## **Sunderland Brook Tributary Report: Phase 2 Stream Geomorphic Assessment Summary**

**November 20, 2007**

QA Notes For: **Sunderland Brook (Reaches T1.01 & T1.02)**  
Ph2 Assessment by Fitzgerald Environmental Associates, LLC.  
Data checked by Jared Carrano  
October 5, 2007

T1.01 A &  
T1.02 B

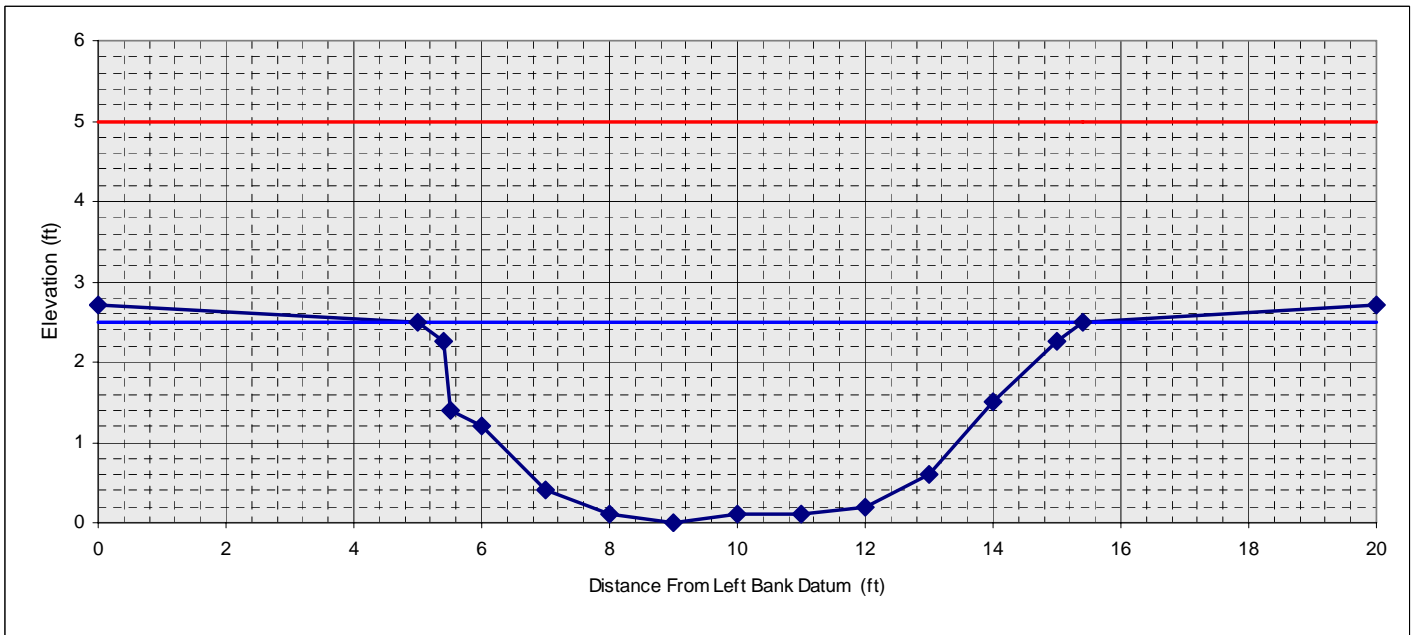
The check in X.1 is asking for an explanation for why you chose “Not Evaluated” for Avg. Largest Particle size. This is because we want people to explain why any feature that could have been evaluated was not. So when NE is selected it requires a comment to pass. If - like in this case - a channel is plane bed, then you can simply select “Not Applicable” and this will eliminate the QC flag. You do not need to select both.

**Updated in DMS (EPF, 10/18/07).**

### Segment T1.01-B

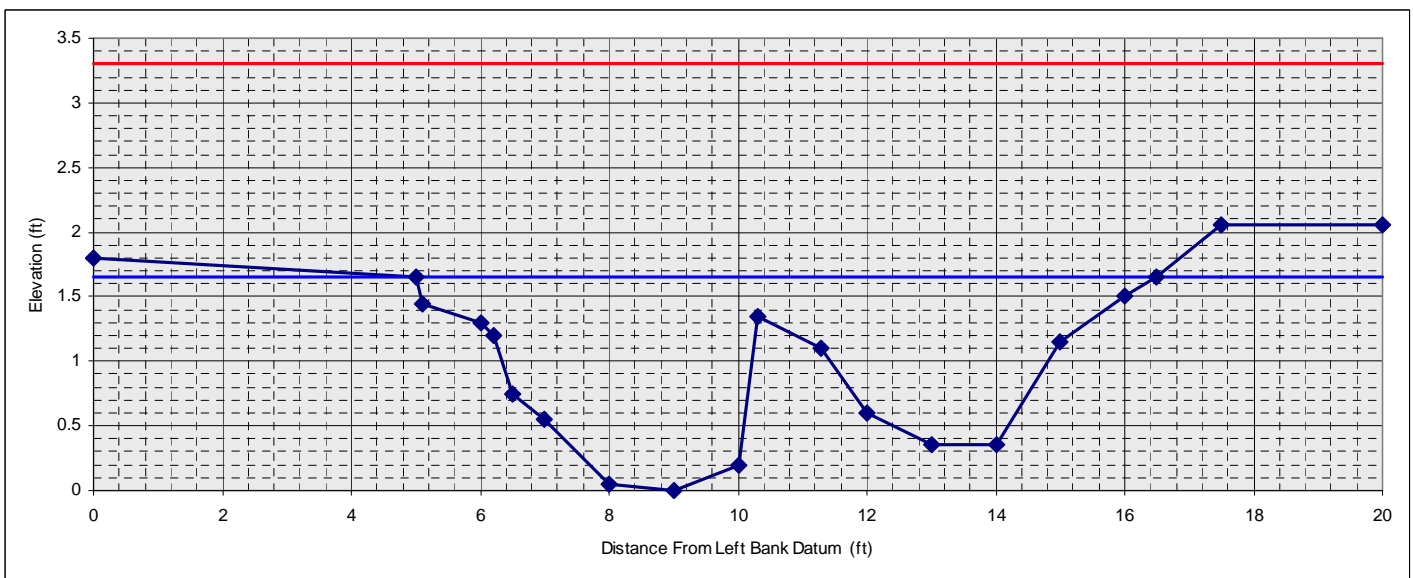
T1.01 B            Step 2.14: Your Width/Depth ratio and Entrenchment ratio would make this a C stream type.  
**The Rosgen system allows for some variance in ratios. ER is slightly outside the B-type range, but all other parameters (esp. slope) support B-type classification (EPF, 10/18/07)**

Step 5: In both your notes and narrative you say that aggradation is prevalent. There are no bars noted or steep riffles noted for this segment. What evidence do you have to support the aggradation you noted?  
**Error in data entry. Mid-channel bars were present and have been entered in DMS (EPF, 10/18/07)**

Step 7: Though you have noted that the degradation was historic; you have an incision ration of 1; making it unclear that any incision has happened. Your channel evolution stage was IV, suggesting a new floodplain has formed at a lower elevation. Does your cross-section data and plot support this? Provide comments in the “notes” to help clarify this discrepancy.

In your comments you noted that widening was prevalent. The width of 12 in the cross-section data is similar to that of the Phase 1 width of 13. There is also no erosion noted in this segment. Is there other evidence to help support the note of prevalent widening?

**Cross-section data supports stage IV. Additional narrative provided in step 5 for clarification (EPF, 10/18/07).**

**Narrative clarified in step 5 to indicate aggradation and planform changes are occurring (EPF, 10/18/07).**

### Segment T1.02-A

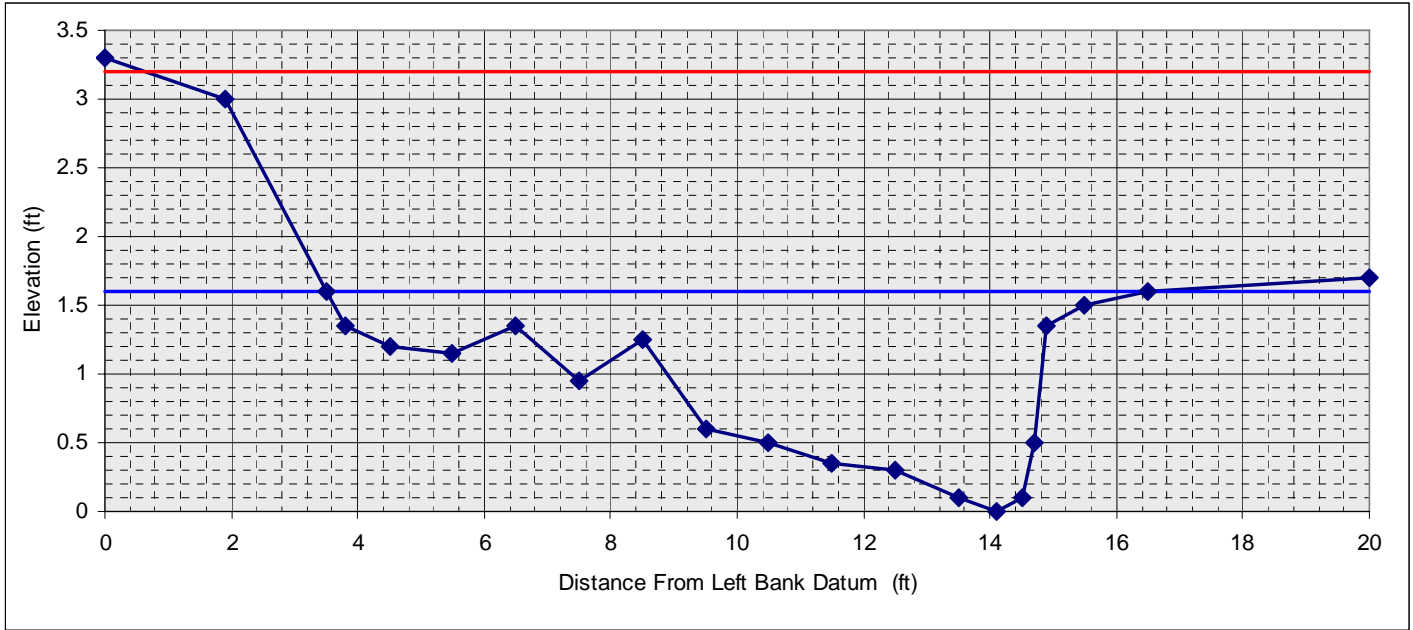
T1.02 A A reach that has departed from a reference bedform of step or riffle-pool to plane bed should not be characterized as having a riffle type of “complete”. You should update the riffle type to either eroded or sedimented, depending on the process that likely lead to the current plane bed system.

**Updated in DMS to sedimented (EPF, 10/18/07).**

### Segment T1.02-B

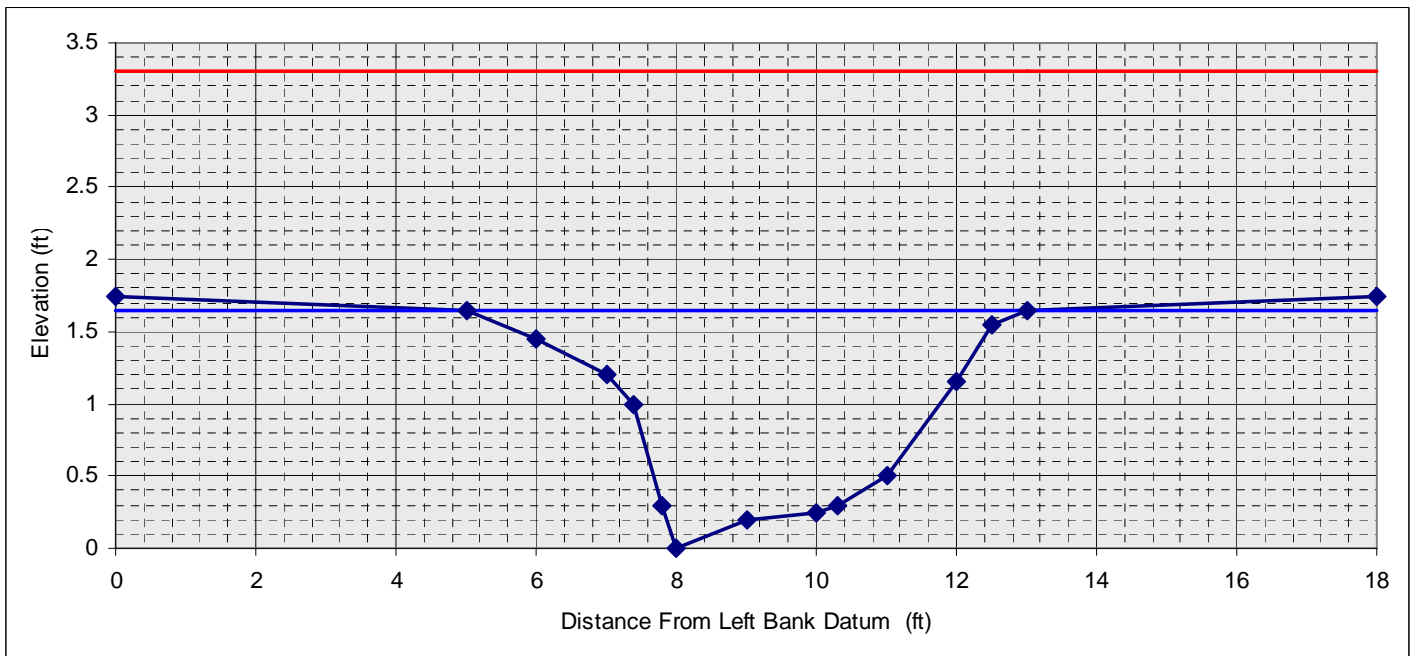
T1.02 B In your notes, you commented that there is a section of bedrock substrate. Is this a grade control? None were noted; but from both the notes and narrative sounded like could be.

**This grade control is continuous from the ledge grade control mapped in the downstream segment. It was not considered a grade control for this segment (EPF, 10/18/07).**
